Access Compliance Report Public Rights-of-Way (Curb Ramps)

Intersection ID: 22474 Main Street: DENMARK RD Cross Street: E_HEBRON_ST Location: NW ADA ID: 310D8274EFF7 Ramp Type: PerpDiag Initial Pass/Fail: Fail **Overall Compliance: No Severity Score:** 25

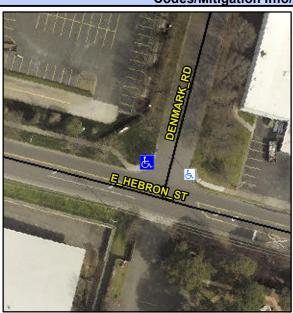
E HEBRON ST Street 1 Name Stop Condition-Street 2 Street 2 Name **DENMARK RD** Stop Condition-Street 1 StopSign Possible Solutions: Remove & Replace Curb Ramp With Two New Directional Ramps or Equivalent. Surveyor Notes: N/A PROW/ADA: Not Found, R304.5.3

| Field Measurements/Component Compliance | | | | | |
|---|-----------------------|-------|------------------------|-----------------------------|-------|
| Yes | Ramp Width (in) | 48.0 | No | Ramp XSlope (%) | 7.6 |
